SECURITY UPGRADES FOR THE
PORT OF UMM QASR, IRAQ

SIGIR PA-05-027
JANUARY 27, 2006

SUBJECT: Report on Project Assessment of the Security Upgrades for the Port of Umm
Qasr, Iraq (Report Number SIGIR-PA-05-027)

Project Assessment of Security Upgrades for the Port of Umm Qasr, Iraq

Site Photo 6. OP Towers

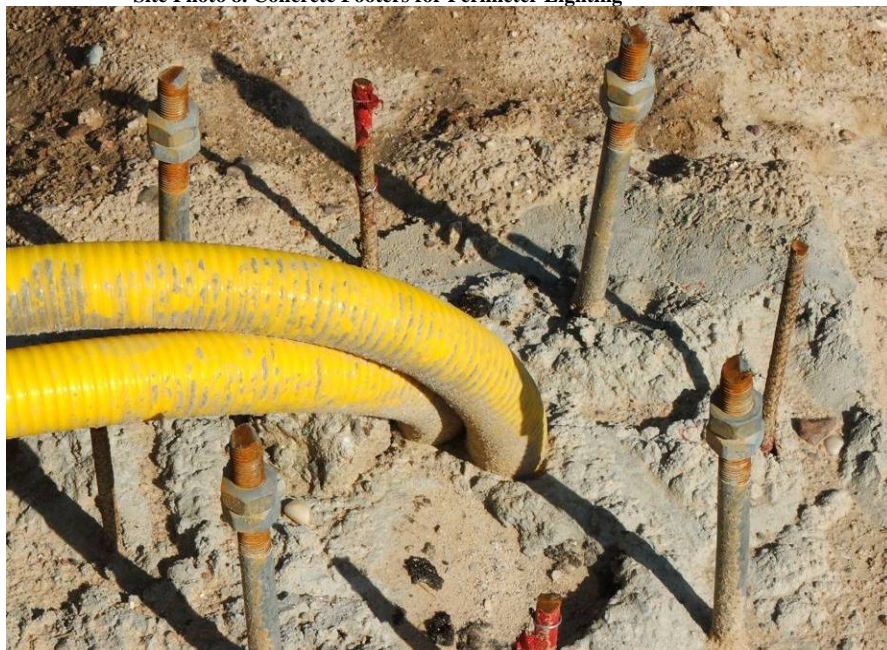
- The fabrication of 19 observation post (OP) towers was in progress at the time of the assessment. The fabrication of the towers was occurring at the north port of Umm Qasr in a secure staging area. Fabrication was almost complete. See Site Photos 6 and 7, respectively for an illustration of the OP towers and the platform. The distance between OP towers was not to exceed 550 meters. Excavation and construction of the reinforced concrete footers and complete fabrication of the OP towers is pending. Placement of the OP towers should be completed after the footings are finished. At the time of the assessment it appeared that the OP towers fabrication would meet design specifications.
